V2500-A5/D5 SERIES PROPULSION SYSTEMS SERVICE BULLETIN

This document transmits the Initial Issue of Service Bulletin EV2500-73-0171

ENGINE FUEL AND CONTROL – FUEL METERING UNIT – INTRODUCTION OF A REVISED TRW FUEL
METERING UNIT WITH SUPPLEMENTARY SOV TORQUE MOTOR CAP CLAMPING

ENGINE - FUEL AND CONTROL - CLAMPS TO REINFORCE SOV TORQUE MOTOR FLANGE

Figure 1

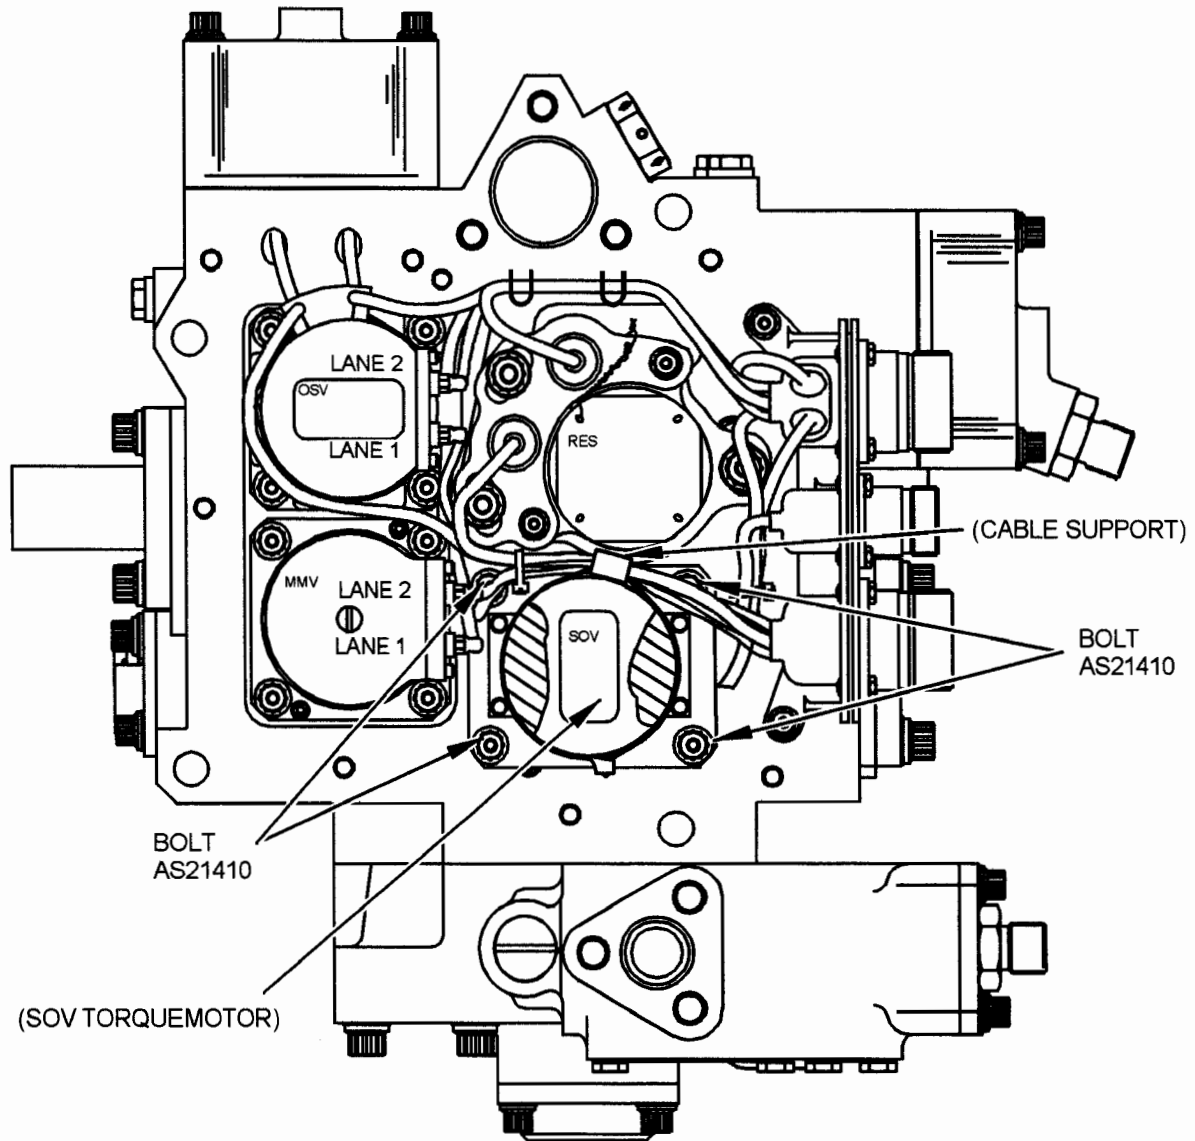
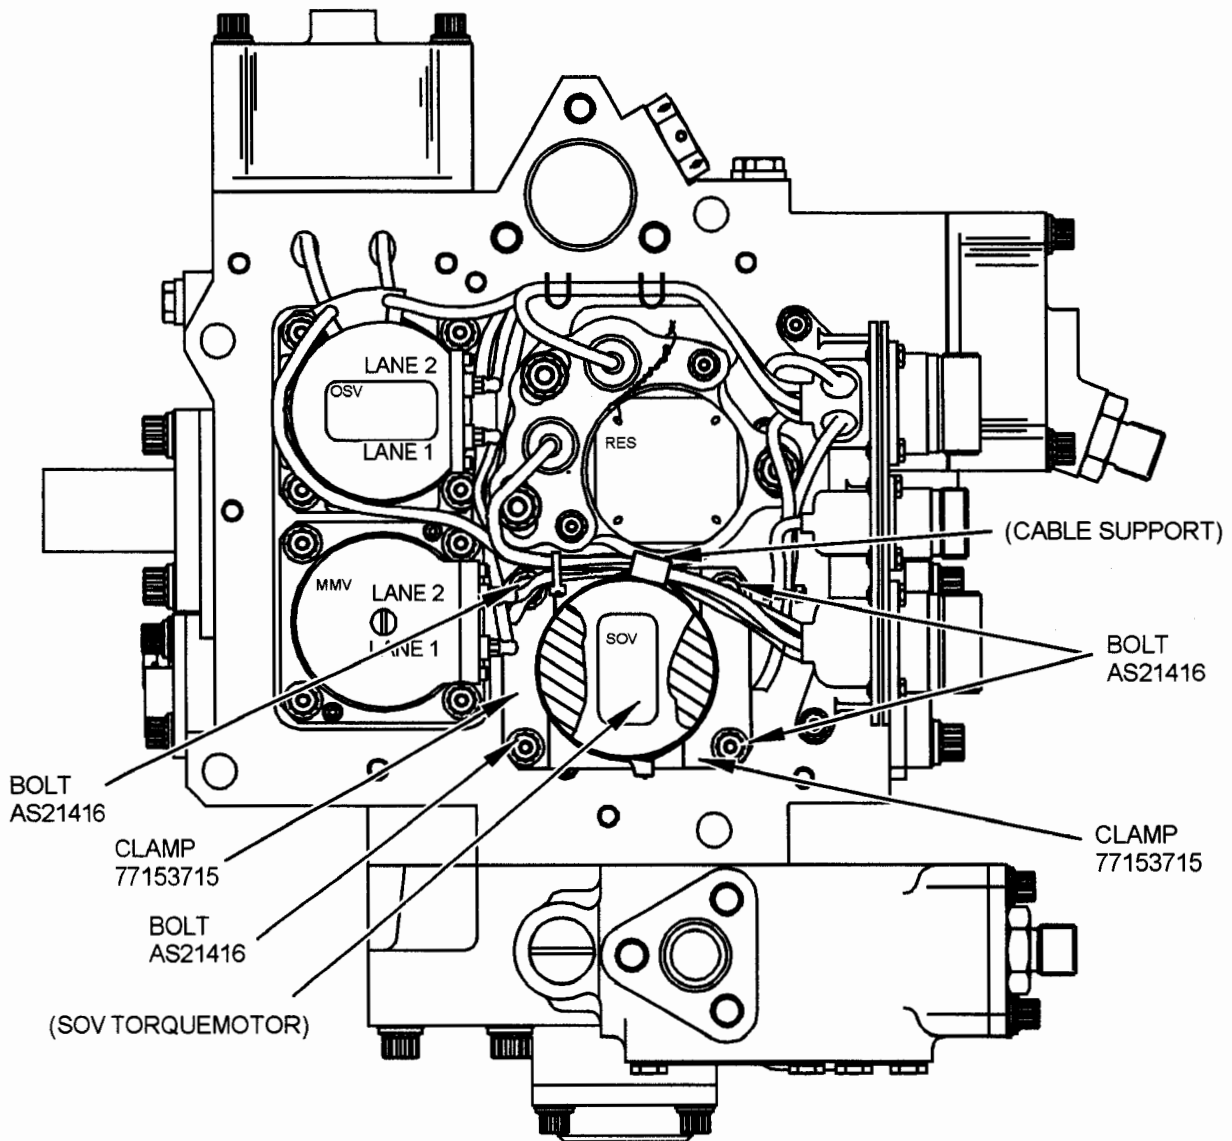
- (1) This modification introduces a pair of C-shaped clamps to reinforce the flange of the Moog Shut-Off Valve (SOV) torque motor and, in the event of a torque motor cap failure by over-pressurisation, to prevent liberation of the cross-drilling plugs.

- (1) Remove only two bolts (AS21410) from the SOV torque motor, Ref. Fig 1
- (2) Position the cable ties and cable support on the SOV torque motor body to give sufficient clearance to let one of the reinforcing clamp (77153715) to be put into position, Ref. Fig 2.
- (3) Install one reinforcing clamp (77153715), Ref. Fig 3.
- (4) Install two bolts (AS21416) and tighten to secure the reinforcing clamp (77153715) in position. Torque tighten the two bolts (AS21416) to 36 lbf in. (4,1 Nm).
- (5) Do steps (1), (2), (3) and (4) again for the other reinforcing clamp (77153715).
- (6) Make sure all the cables are clear of the two reinforcing clamps (77153715) and the retaining bolts (AS21416).
- (7) Refer to TEST and test the FMU.
- (8) Refer to ASSEMBLY, and install the heatshield

CAUTION: DO NOT REMOVE ALL FOUR BOLTS WHICH SECURE THE TORQUE MOTOR SERVO VALVE AT THE SAME TIME. MAKE SURE ONE CLAMP IS INSTALLED AND THE TWO BOLTS TORQUE TIGHTENED BEFORE THE SECOND CLAMP IS INSTALLED.

Before Modification
Figure 1

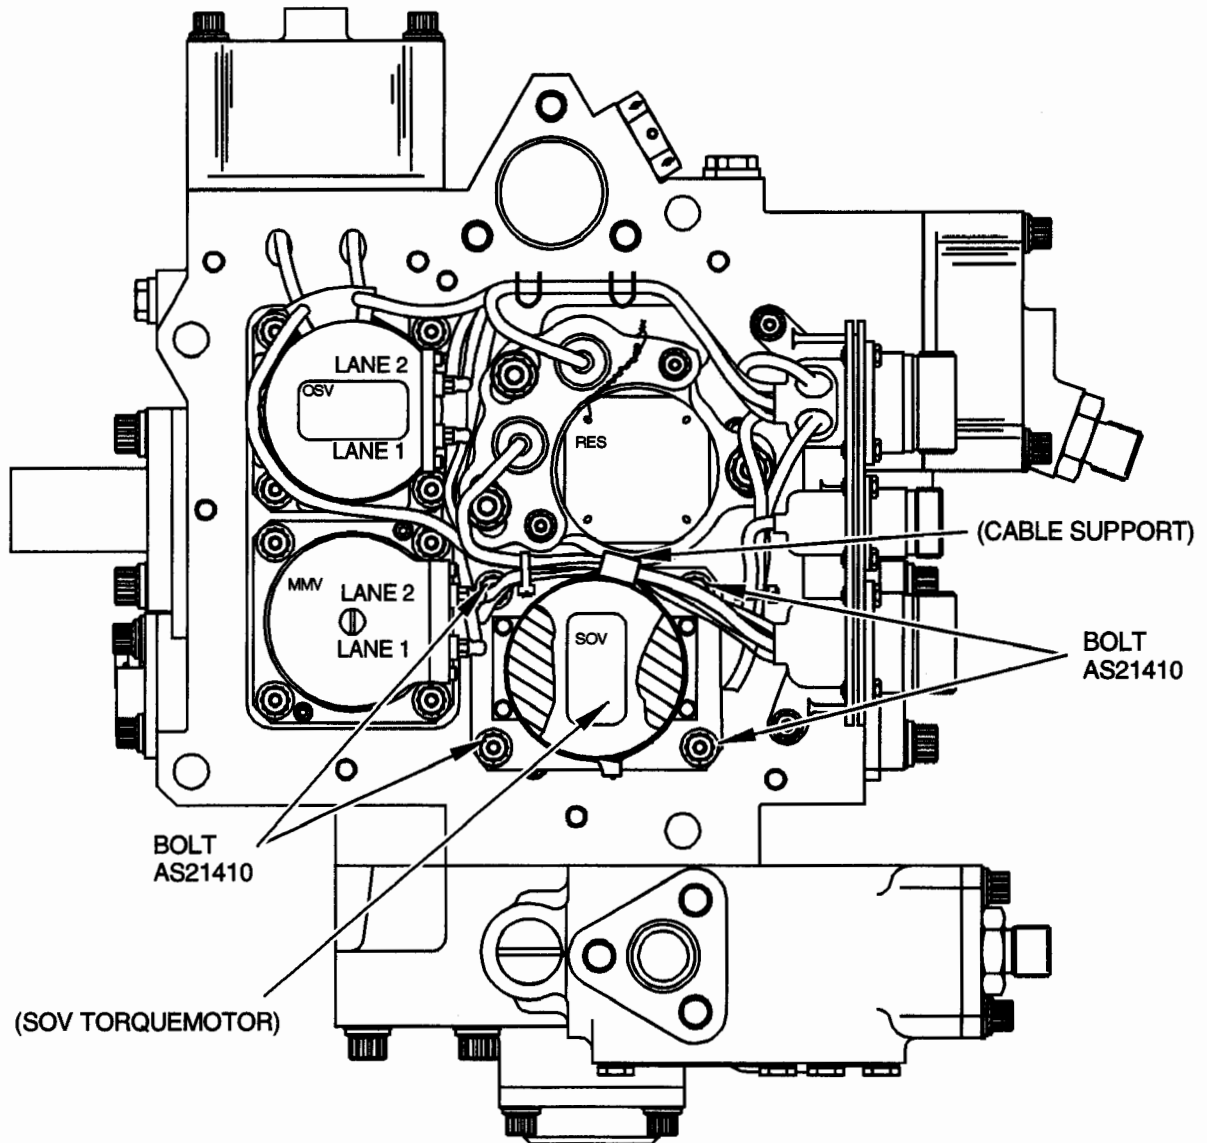
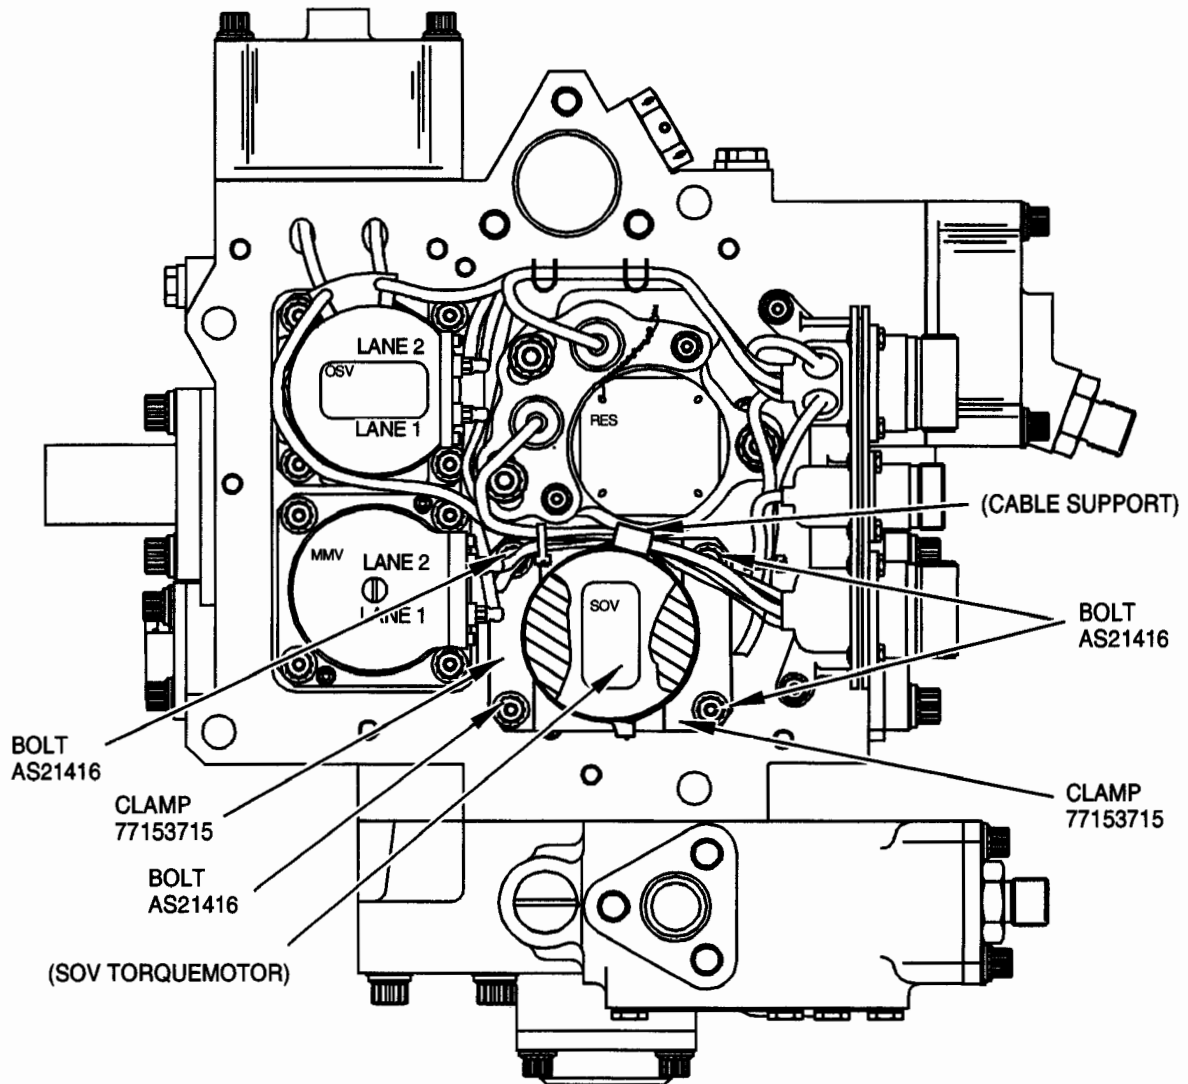
- (1) This modification introduces a pair of C-shaped clamps to reinforce the flange of the Moog Shut-Off Valve (SOV) torque motor and, in the event of a torque motor cap failure by over-pressurisation, to prevent liberation of the cross-drilling plugs.

- (1) Remove only two bolts (AS21410) from the SOV torque motor, Ref. Fig 1
- (2) Position the cable ties and cable support on the SOV torque motor body to give sufficient clearance to let one of the reinforcing clamp (77153715) to be put into position, Ref. Fig 2.

- (3) Install one reinforcing clamp (77153715), Ref. Fig 3.
- (4) Install two bolts (AS21416) and tighten to secure the reinforcing clamp (77153715) in position. Torque tighten the two bolts (AS21416) to 36 lbf in (4.1 Nm).

CAUTION: DO NOT REMOVE ALL FOUR BOLTS WHICH SECURE THE TORQUE MOTOR SERVO VALVE AT THE SAME TIME. MAKE SURE ONE CLAMP IS INSTALLED AND THE TWO BOLTS TORQUE TIGHTENED BEFORE THE SECOND CLAMP IS INSTALLED.

- (5) Do steps (1), (2), (3) and (4) again for the other reinforcing clamp (77153715).
- (6) Make sure the cables are clear of the two reinforcing clamps (77153715) and the retaining bolts (AS21416).

Figure 1

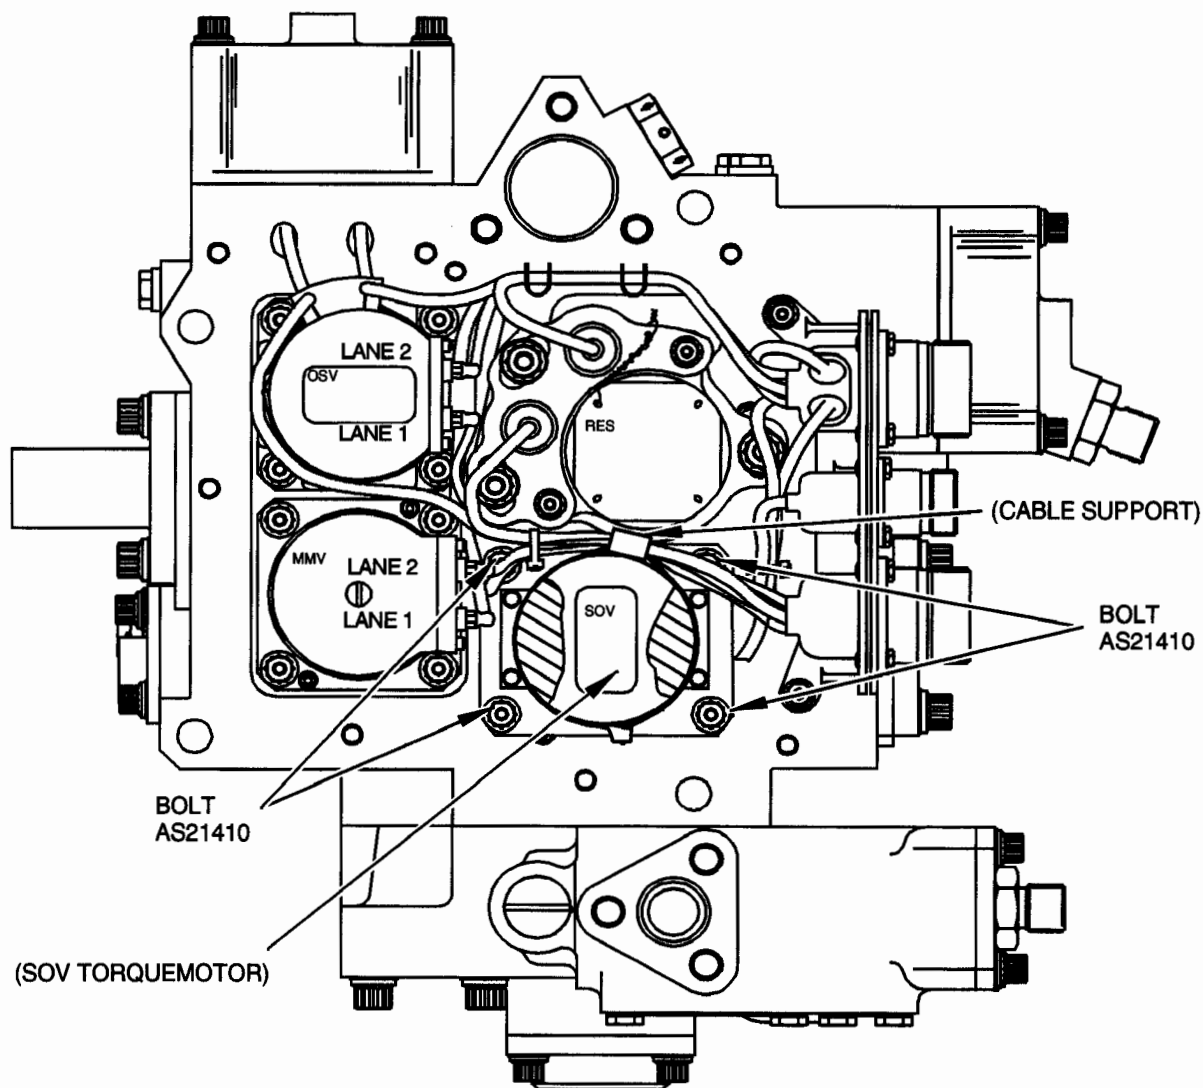
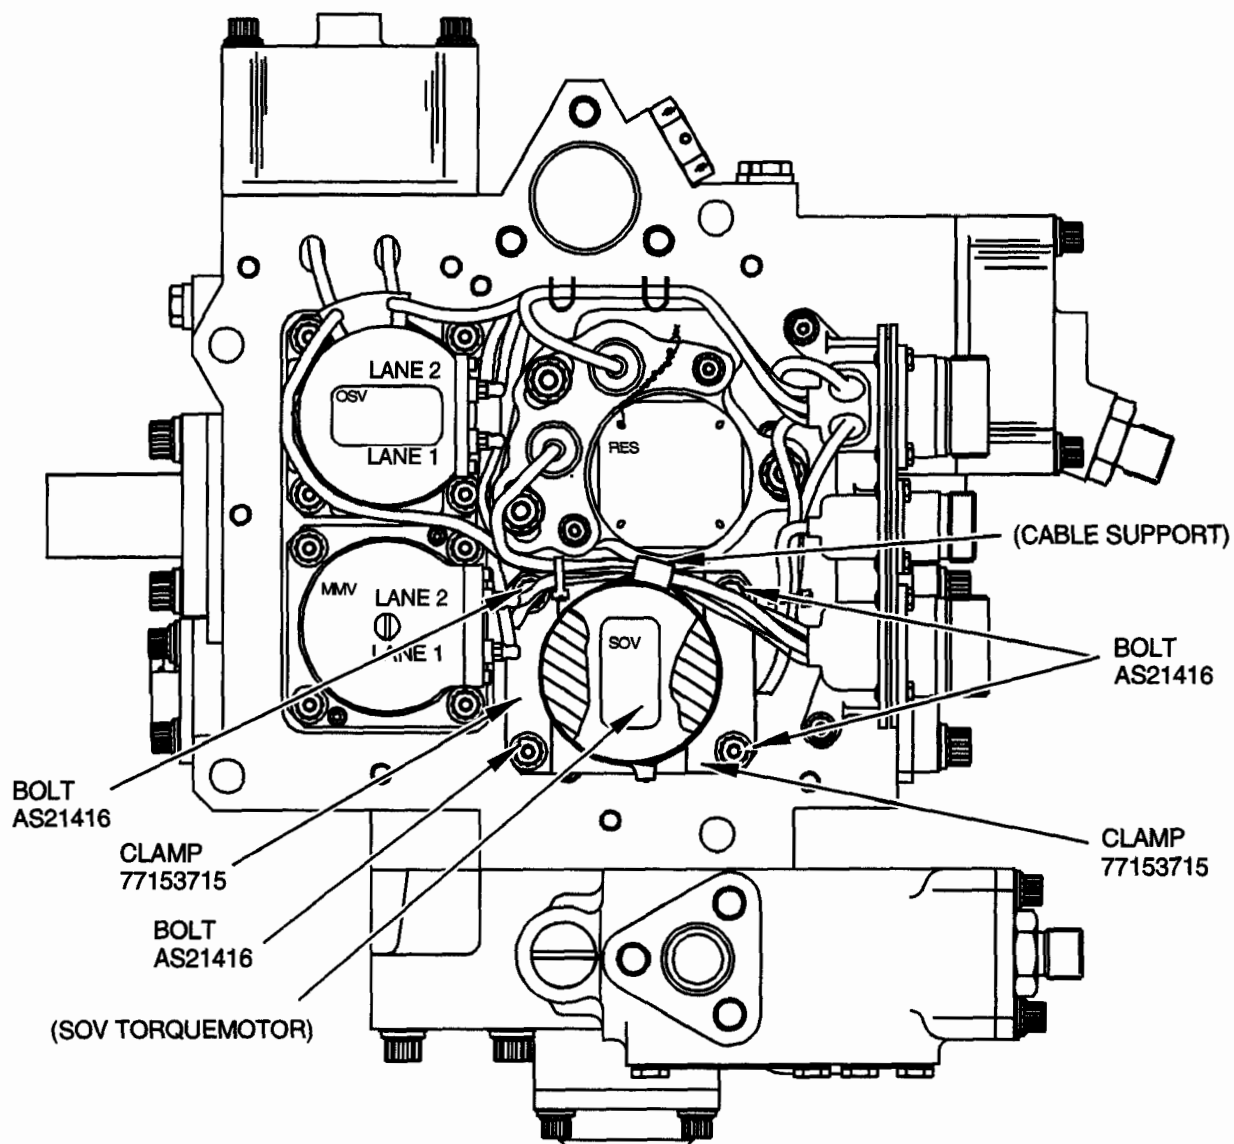
- (1) This modification introduces a pair of C-shaped clamps to reinforce the flange of the Moog Shut-Off Valve (SOV) torque motor and, in the event of a torque motor cap failure by over-pressurisation, to prevent liberation of the cross-drilling plugs.

- (1) Remove only two bolts (AS21410) from the SOV torque motor, Ref. Fig 1
- (2) Position the cable ties and cable support on the SOV torque motor body to give sufficient clearance to let one of the reinforcing clamp (77153715) to be put into position, Ref. Fig 2.

- (3) Install one reinforcing clamp (77153715), Ref. Fig 3.
- (4) Install two bolts (AS21416) and tighten to secure the reinforcing clamp (77153715) in position. Torque tighten the two bolts (AS21416) to 36 lbf in. (4,1 Nm).

CAUTION: DO NOT REMOVE ALL FOUR BOLTS WHICH SECURE THE TORQUE MOTOR SERVO VALVE AT THE SAME TIME. MAKE SURE ONE CLAMP IS INSTALLED AND THE TWO BOLTS TORQUE TIGHTENED BEFORE THE SECOND CLAMP IS INSTALLED.

- (5) Do steps (1), (2), (3) and (4) again for the other reinforcing clamp (77153715).
- (6) Make sure the cables are clear of the two reinforcing clamps (77153715) and the retaining bolts (AS21416).
